UNITED STATES PATENT AND TRADEMARK OFFICE

| APPLICATION NO. | FILING DATE | FIRST NAMED INVENTOR | ATTORNEY DOCKET NO. | CONFIRMATION NO. |
|---------------------------|-------------|----------------------|---------------------|------------------|
| 09/516,753 | 03/01/2000 | Gregory Pinchasik | 2390/49701 | 3706 |

| Office Action Summary | Application No. 09/516,753 | Applicant(s) PINCHASIK ET AL. | |

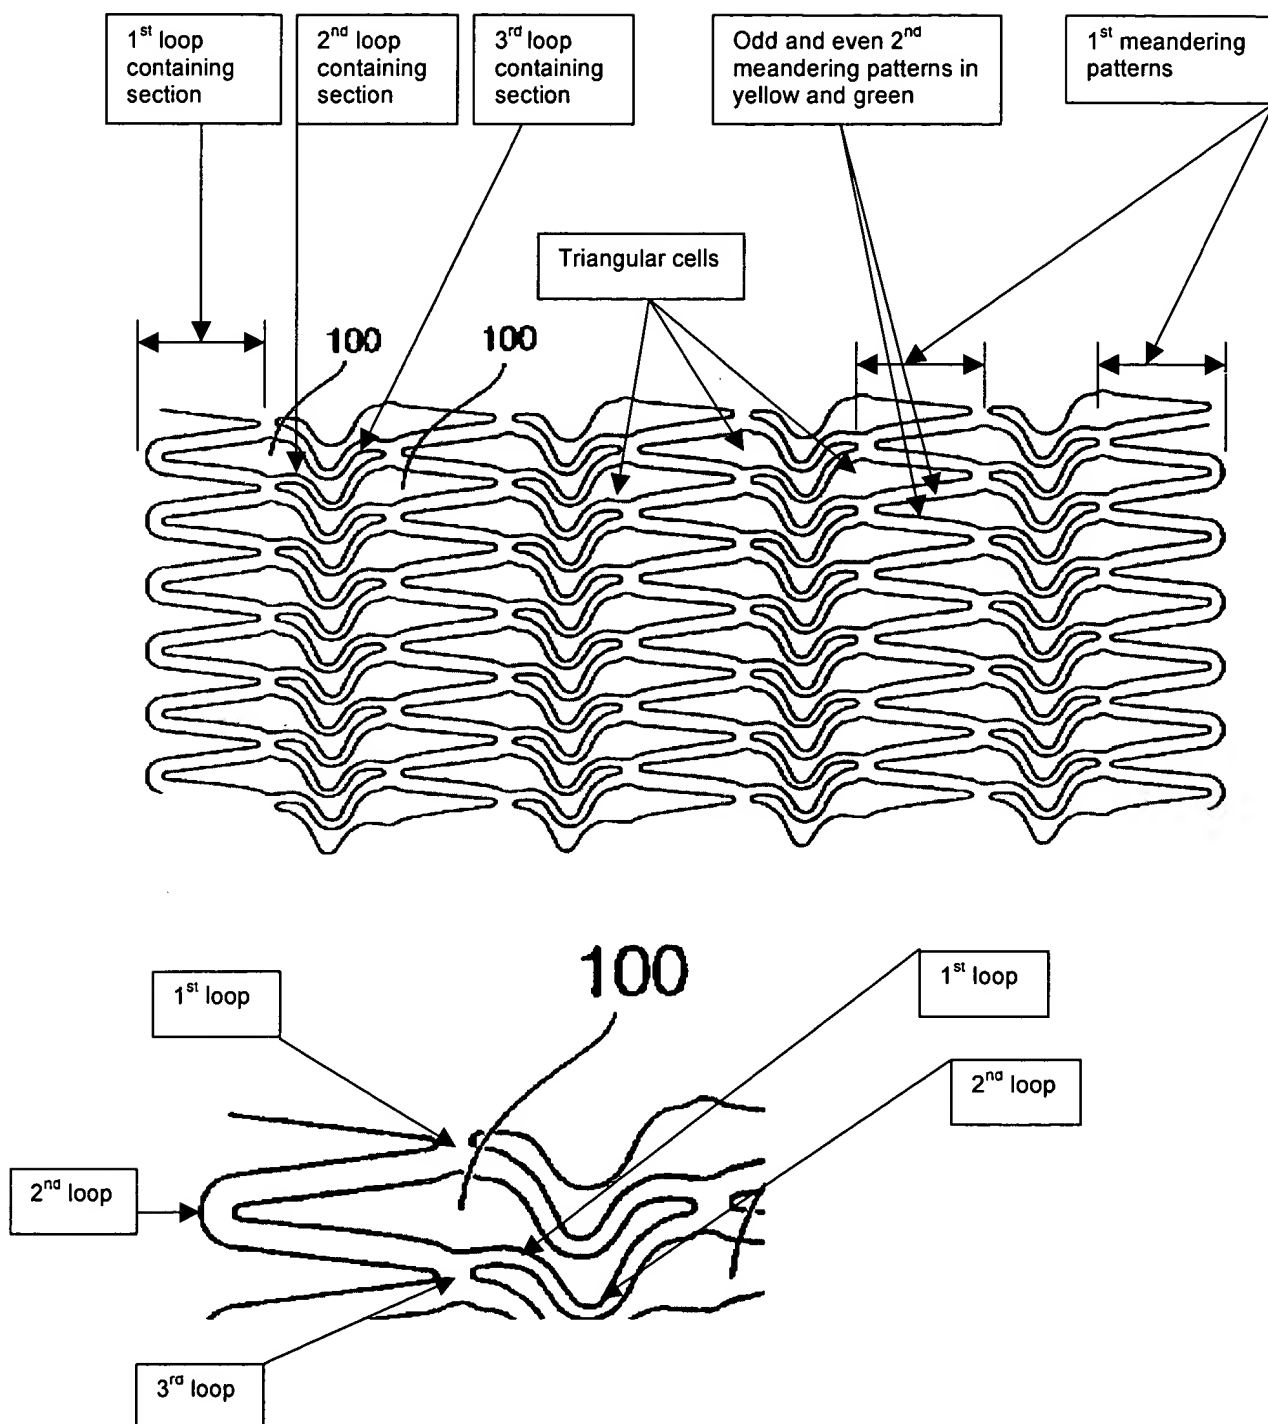
Von Oepen-'634 (Fig. 10 as presented on page 3) discloses substantially all limitations as recited in the claims.

1. Rejection over Von Oepen-WO 98/35634: please notice that because all struts/loops/legs of Von Oepen-'634 stent define a cylindrical body, therefore they are indeed parallel to or orient along the longitudinal axis of the stent. Further, Von Oepen-'634 shows in page of this "Office Action" shorter legs in one same loop containing section.
